ADDENDUM A

Staff Report: Z-12-18-2

(LMC Kierland PUD)

June 6, 2018

BUILDABLE AREA EXHIBIT

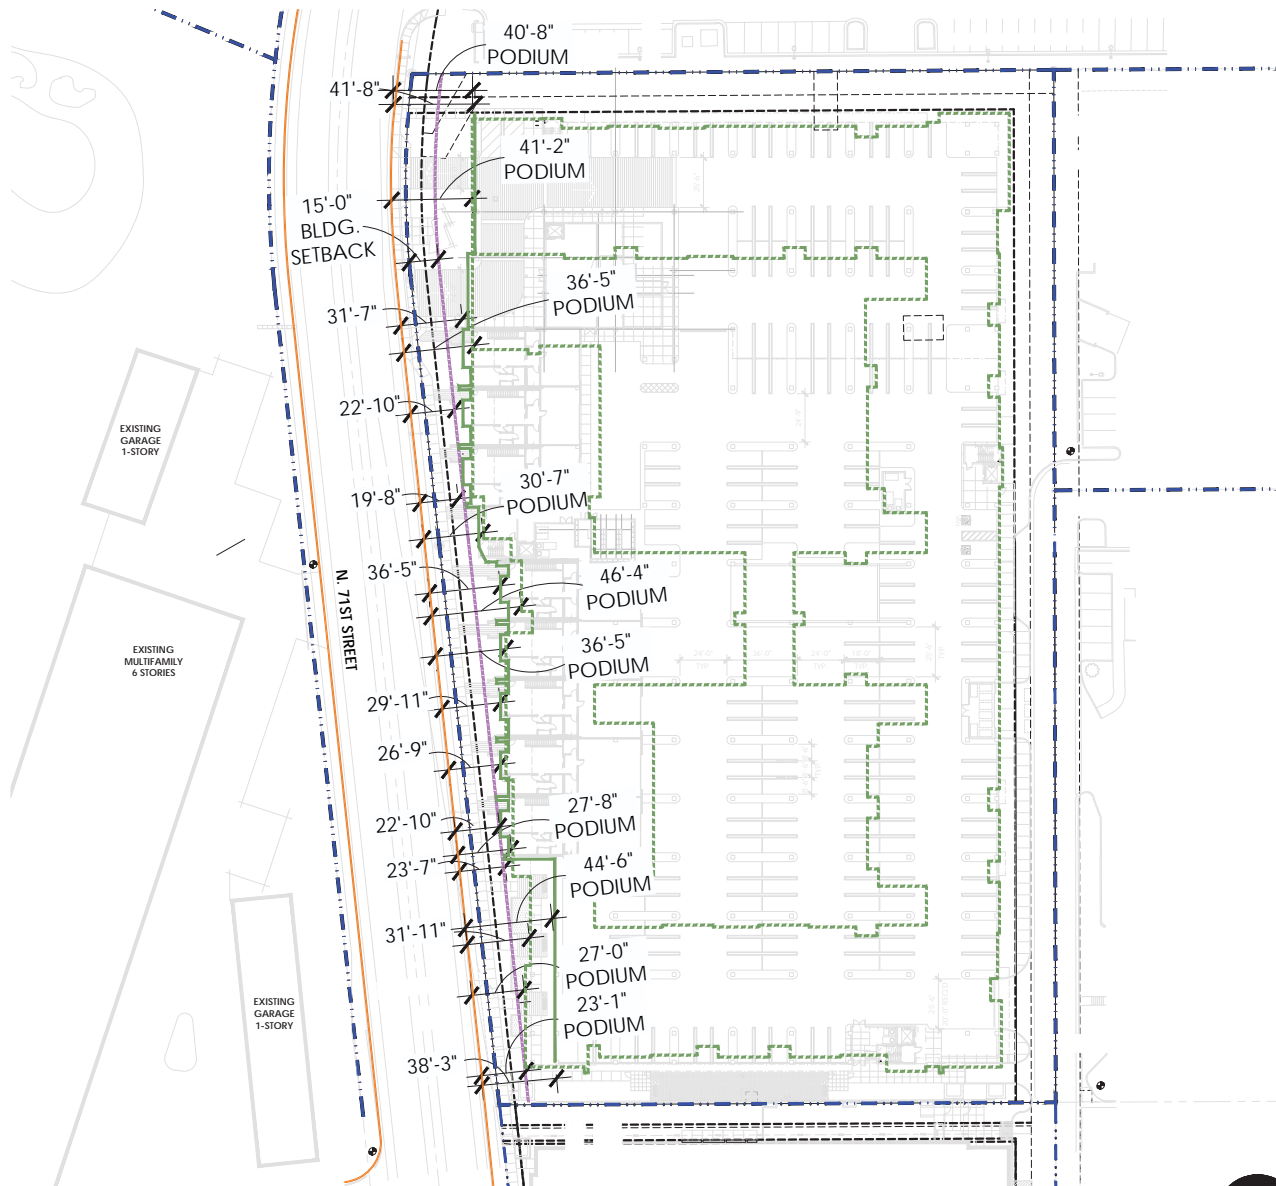
As a result of ongoing dialogue with the area residents the applicant is proposing an update to the frontage standards along 71st Street for the project. The updated frontage includes an additional 5-foot landscape and building setback in order to provide approximately 3,300 square feet of open space that is to be open to the public. The “Urban Park” as identified in Exhibit A, is located at the southwest corner of the site. Exhibit B depicts the modified building setback along the western property line in relation to the building. The urban park will include a shaded seating area, alternative paving and synthetic turf. Stipulations 1.i.6, 1.j and 1.l through s have been modified and/or added to address the inclusion of the urban park element as shown in Exhibit A and Exhibit B date stamped June 6, 2018.

o. EXHIBIT M.9, CONCEPTUAL SITE PLAN: UPDATE AND REPLACE TO DEMONSTRATE 15-FOOT LANDSCAPE AND BUILDING SETBACK. ALSO IDENTIFY THE OPEN SPACE AREA AND NOTE THAT THE AREA SHALL REMAIN OPEN TO THE PUBLIC ALONG 71ST STREET FROM DAWN TO DUSK TO BE CONSISTENT WITH THE EXHIBITS DATE STAMPED JUNE 6, 2018.

PROPOSED MINIMUM BUILDING SETBACK = 15'-0"
(PROPERTY LINE TO LIMIT OF BUILDABLE AREA)

AVERAGE SETBACK FROM CURB
(BACK OF CURB TO BUILDING FACE)
GROUND FLOOR = +/- 35'-4"
PODIUM ABOVE = +/- 34'-8"

AVERAGE SETBACK FROM PROPERTY LINE
(PROPERTY LINE TO BUILDING FACE - N.I.C. 7'-6")
LANDSCAPE AREA FROM PROPERTY LINE TO
BACK OF CURB)
GROUND FLOOR = 27'-10"
PODIUM ABOVE = 27'-2"
